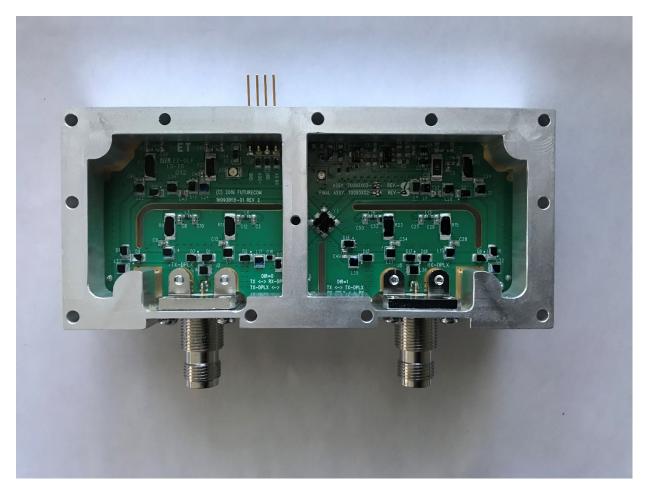
Finger stock was added on both long partition edges.

The cover is 4mm larger and the upper corner screws were added

Foil was added on the EMI gasket

The cover is 4mm larger and screws were added in upper corners.

The cover now displays DVR-LX.

New TNC connectors.
